11-09 LATEST REVISION DATE	 APPROVED BY BRIDGE ENGINEER	 Iowa Department of Transportation Highway Division	
		STANDARD DESIGN - 44' ROADWAY, THREE SPAN BRIDGE PRETENSIONED PRESTRESSED CONCRETE BEAM BRIDGES MARCH, 2007	
		SUBDRAIN DETAILS	H44-74-07

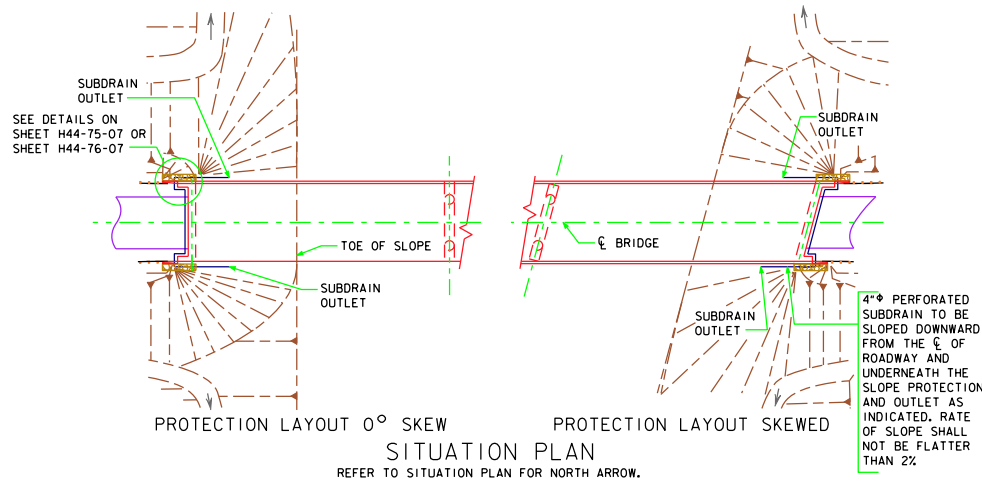
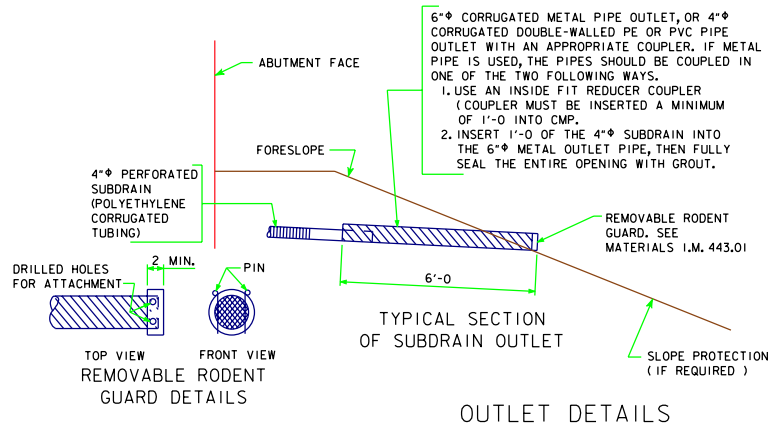
REVISED 11-09 - REMOVED THE GRANULAR BACKFILL DETAIL.
